Calvert Cliffs Nuclear Power Plant, Units 1 and 2
Renewed Facility Operating License Nos. DPR-53 and DPR-69
Docket Nos. 50-317 and 50-318

Subject: August 2014 Six-Month Status Report in Response to March 12, 2012 Commission Order Modifying Licenses with Regard to Reliable Spent Fuel Pool Instrumentation (Order Number EA-12-051)

**SIX-MONTH STATUS REPORT (AUGUST 2014)
FOR RELIABLE SPENT FUEL POOL INSTRUMENTATION**

**Response to
Request for Additional Information
From
Interim Staff Evaluation on Reliable Spent Fuel Pool Instrumentation
Dated November 15, 2013
Calvert Cliffs Nuclear Power Plant, Units 1 & 2
Docket Numbers 50-317 and 50-318**

Figure 1.1, CCNPP Spent Fuel Pool Elevation View Sketch

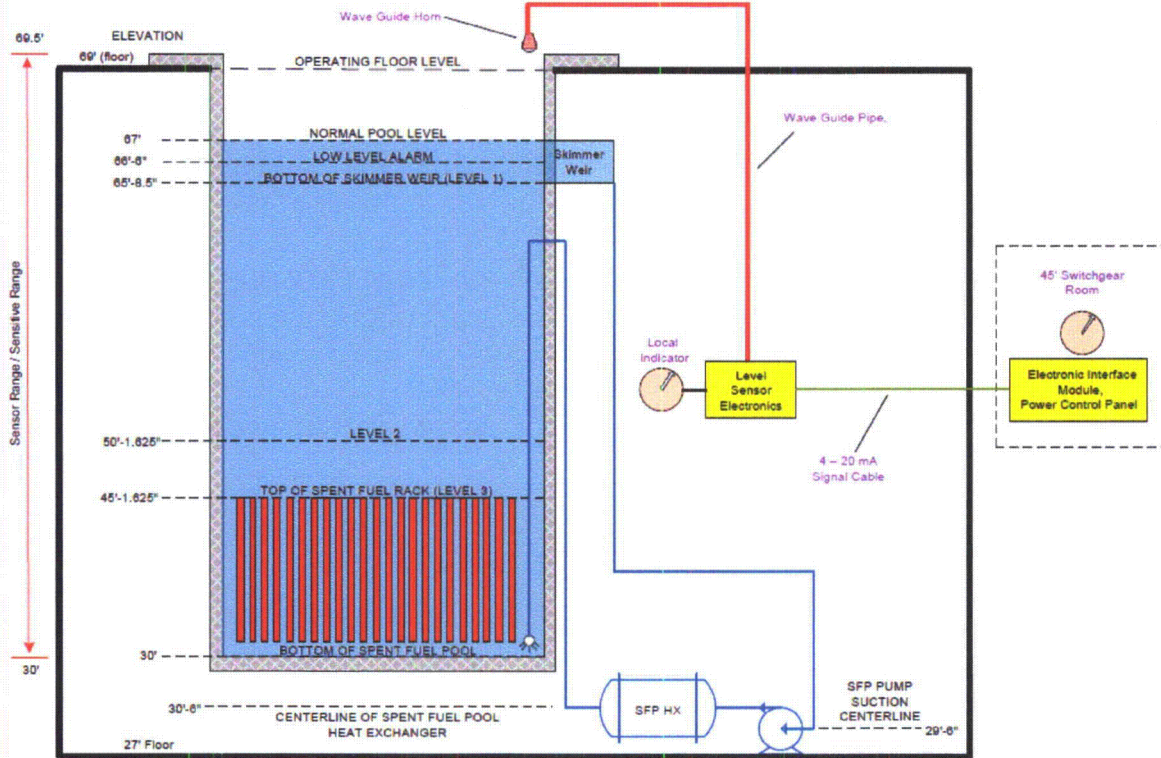
For Level 1, please specify how the identified location represents the HIGHER of the two points described in the NEI 12-02 guidance for this level.

As indicated in Figure 1.1, CCNPP designated Level 1 to be at the 65 foot 8.5 inch level of the spent fuel pool. This level corresponds to the bottom of the spent fuel pool skimmer weir, 3 inches below the low water alarm setpoint. Level 1 is selected to ensure that a void will not occur in the suction lines. Analysis has demonstrated that there is adequate NPSH for pump operation at saturated conditions for water at Level 1.

Thus Level 1 is the higher of the two pump-limiting conditions specified in NEI 12-02.

Figure 3.1, 45' Unit 1 Primary Level Cable Route

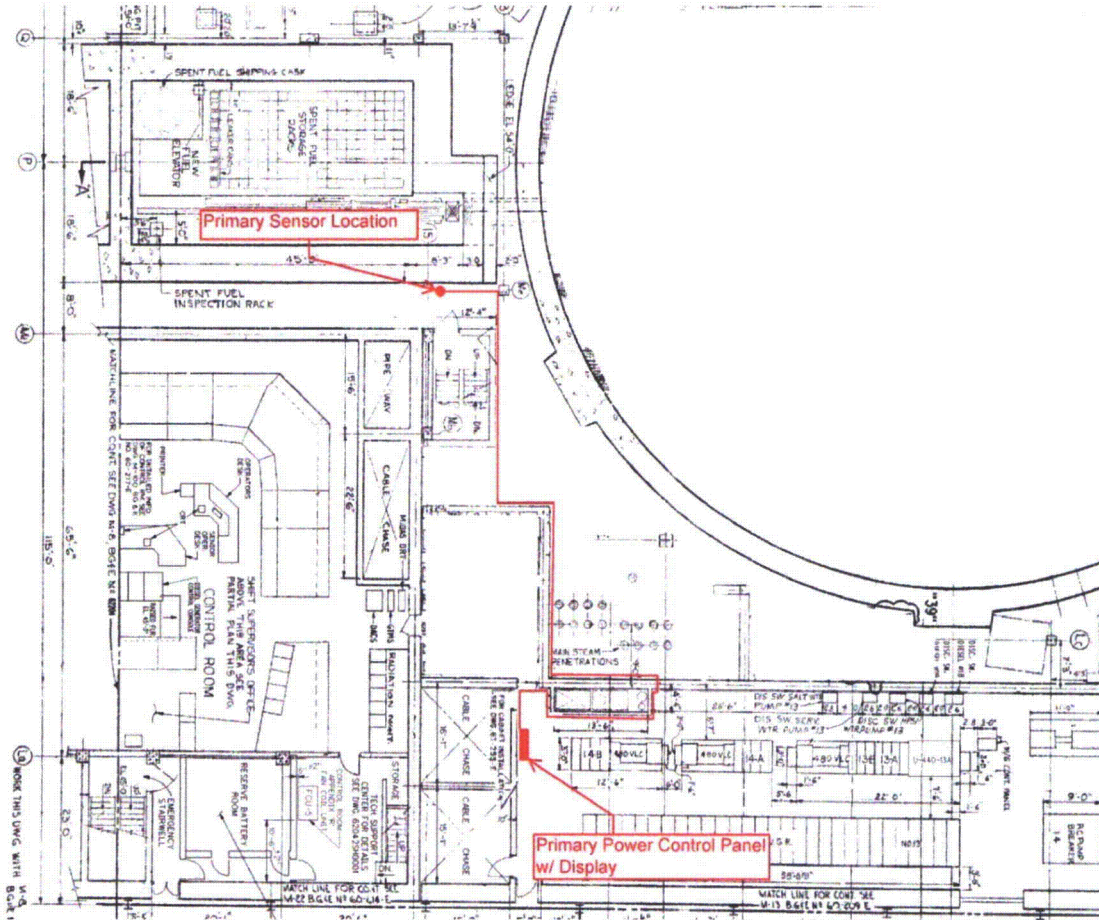
Please provide additional information describing how the proposed arrangement of the conduit and routing of the cabling between the spent fuel and the location of the read-out/display device meet the guidance to arrange the SFP level instrument channels in a manner that provides reasonable protection of the level indication function against missiles that may result from damage to the structure over the SFP.

There are no cables or conduit routed in the SFP area for this installation, but rather a waveguide antenna horn and approximately 8 feet of waveguide antenna tubing for each channel. The waveguide horns are mounted at opposite ends of the SFP and therefore physically separated to preclude missile damage to both channels. The SFP is a seismic Category I structure; therefore, in the SFP area above the pool, all equipment is required to meet Seismic II/I mounting requirements to ensure it does not fall and create a missile during a seismic event equal to the design basis of the SFP.

See Figures 3.1 and 3.2 for primary and back-up channel cable and conduit routing between the sensor and the display panel for each channel. As can be seen in the figures, each route is physically separated from each other to prevent a missile from damaging both channels.

Figure 14.1, Primary Channel Power Supply Source 1L12

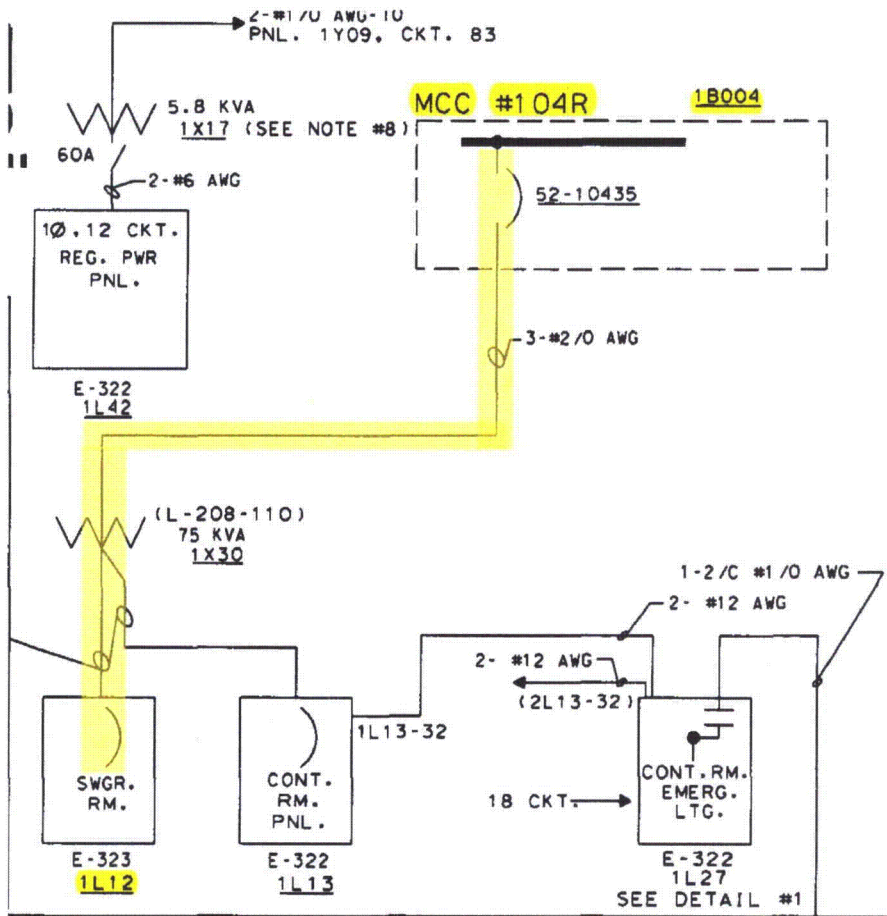
Please provide the NRC staff with the final configuration of the power supply source for each channel so that the staff may conclude that the two channels are independent from a power supply assignment perspective.

The primary channel receives normal AC power from Unit 1 lighting panel 1L12 while the back-up channel receives power from Unit 2 lighting panel 2L07. Figures 14.1 and 14.2 are marked-up single line diagrams identifying the upstream source for each channel. As can be seen, each channel is powered from an independent AC source during normal operation. Normal power supply to the primary SFP Wide Range Level Indicator (WRLI) is from a Unit 1 motor control center (MCC) and the backup SFP WRLI is from a Unit 2 MCC; however, during an ELAP power is automatically transferred to a battery backup within each of the power control panels. This feature was tested during the Factory Acceptance Test and was satisfactory. The loss of AC power test will be performed on site during the Site Acceptance Test following completion of field implementation activities.
